2020 Corvette: Service Bulletin:: #20-NA-179: Malfunction Indicator Lamp (MIL) Illuminated - DTCs P0521 and/or P06DD Set - (Oct 23, 2020)

Subject: Malfunction Indicator Lamp (MIL) Illuminated – DTCs P0521 and/or P06DD Set

Brand:	Model:	Model Year:		VIN Breakpoint:		Engine:	Transmission:
		from	to	from	to		
Chevrolet	Corvette	2020	2020	SORP	September 10, 2020	6.2L (LT2)	—

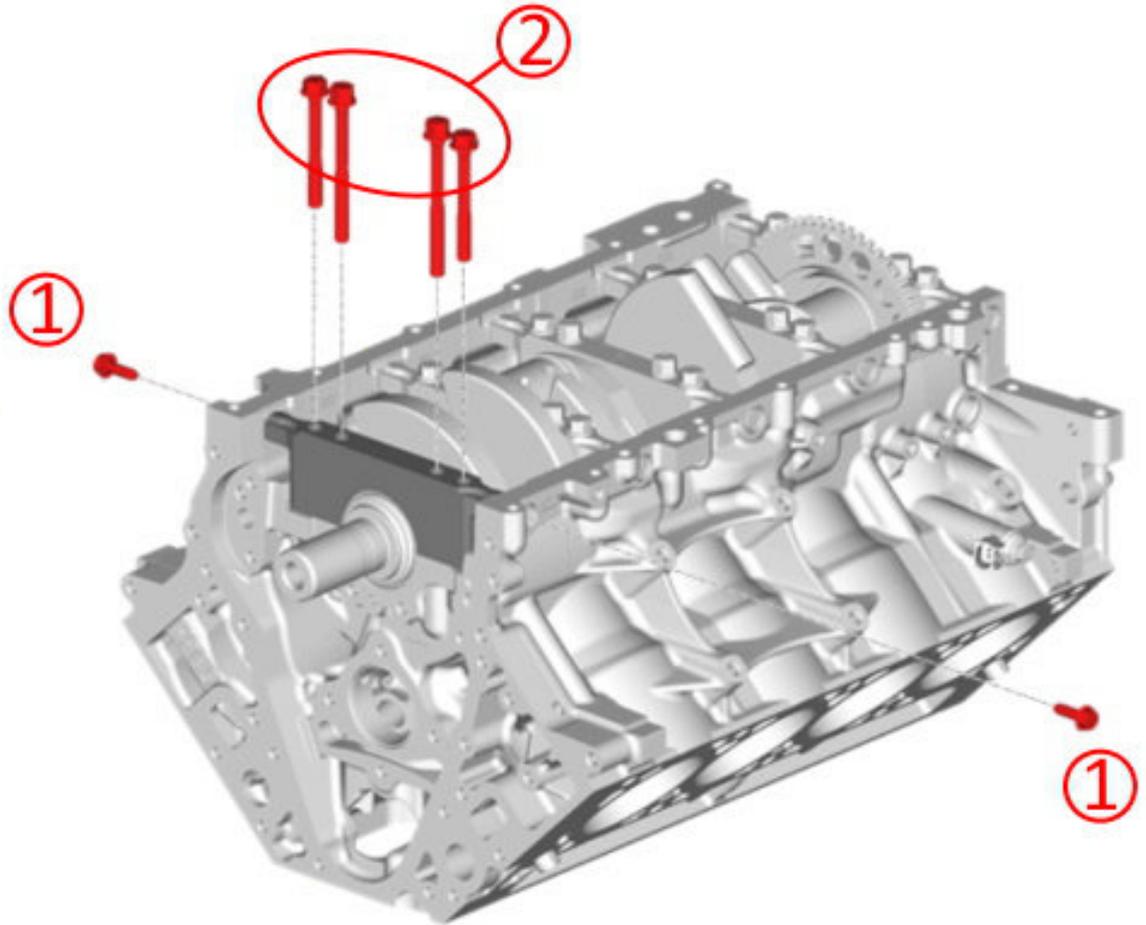
This condition may be caused by an unseated engine oil pressure control valve (OCV).

If P0521 and P06DD DTCs are present, then a redesigned oil pressure control valve retainer clip (1) may be necessary. Refer to the Service Procedure section below.

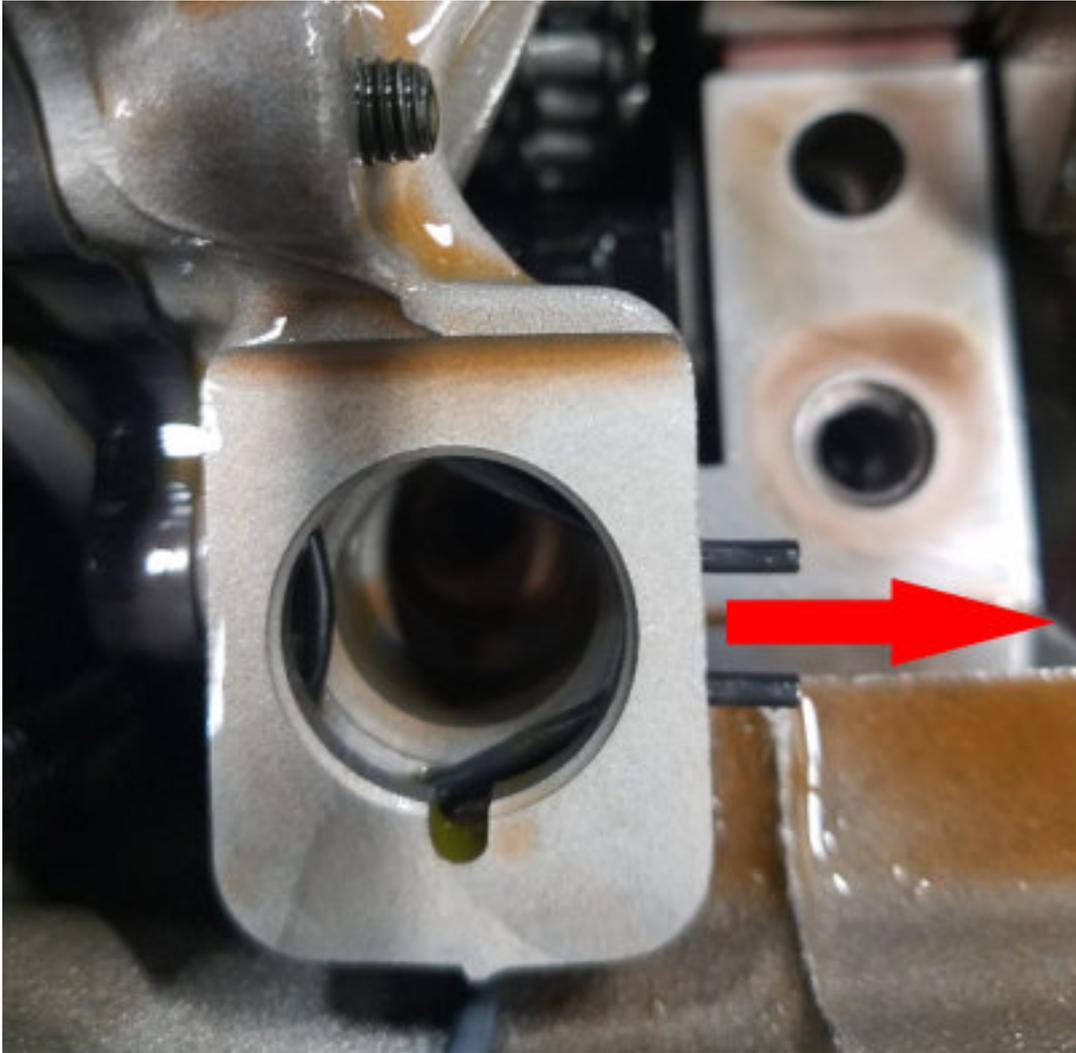
1. Inspect the OCV:
 - If you find this oil pressure control valve dislodged (1), it will be necessary to install a redesigned oil control valve retainer.
- Disconnect the oil pressure control valve electrical connector and position aside.

Note: Remove the existing oil pressure control valve retainer by pulling towards the rear and discard. You will be installing a newly designed retainer during installation.

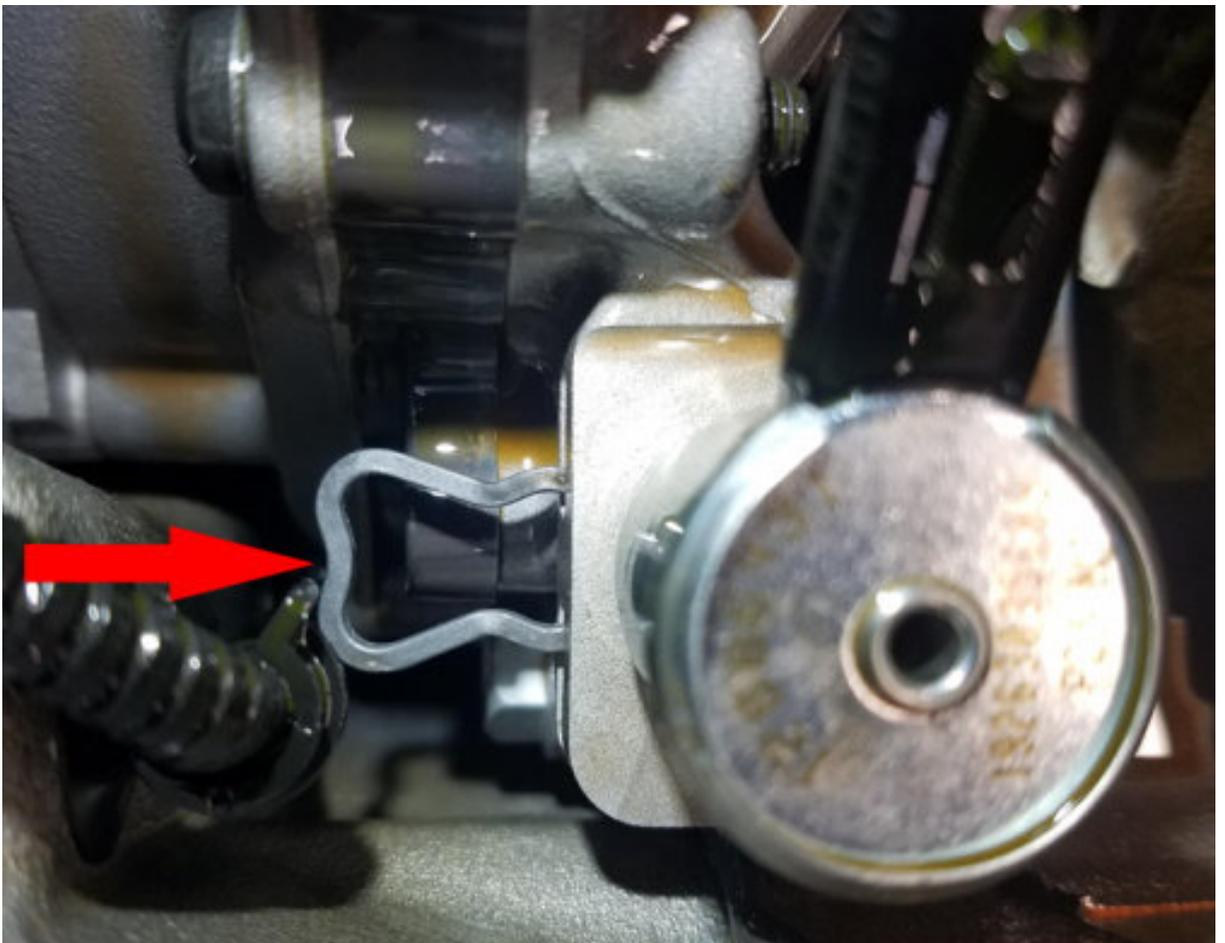
1. Push in the retainer and remove the oil pressure control valve and set aside.
2. Once the retainer is removed, inspect the oil pressure control valve for any signs of damage and ensure the O-ring is not cut.
 - Apply a small amount of clean engine oil to the pressure control valve and reinstall ensuring it is seated correctly.

1. Install the new retainer from the front of engine towards the rear as shown in the graphic above.

1. When the retainer is installed, there should be about 2 to 3 mm of clearance between the retainer and the oil pump body as shown above.
